Access Compliance Report

Public Rights-of-Way

(Curb Ramps)

Intersection ID: 11194	Main Street: FLAMINGO_AV	Cross Street: SPRINGWAY_DR	Location: NE
ADA ID: 9FA0F79E1CE6	Ramp Type: Para	Initial Pass/Fail: Pass	Overall Compliance: No
		Severity Score: 0

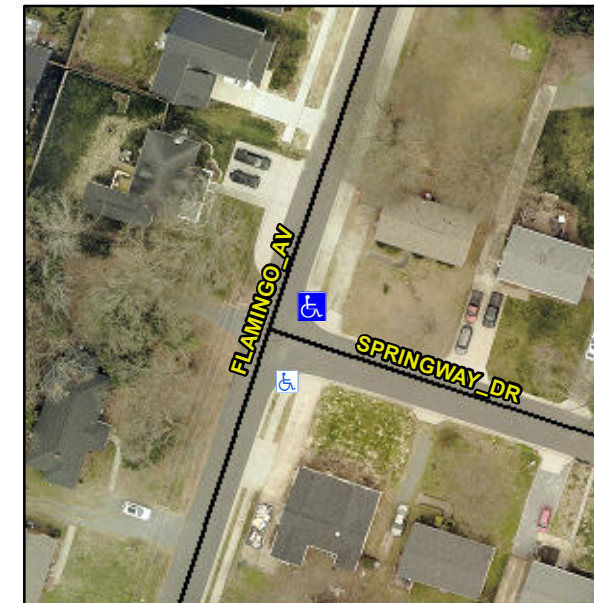
Surveyor Notes:

RT RP < 5%

PROW/ADA:

Not Found, R304.2.1, R304.5.3, R305.2

Possible Solutions:

Remove & Replace Entire Ramp.
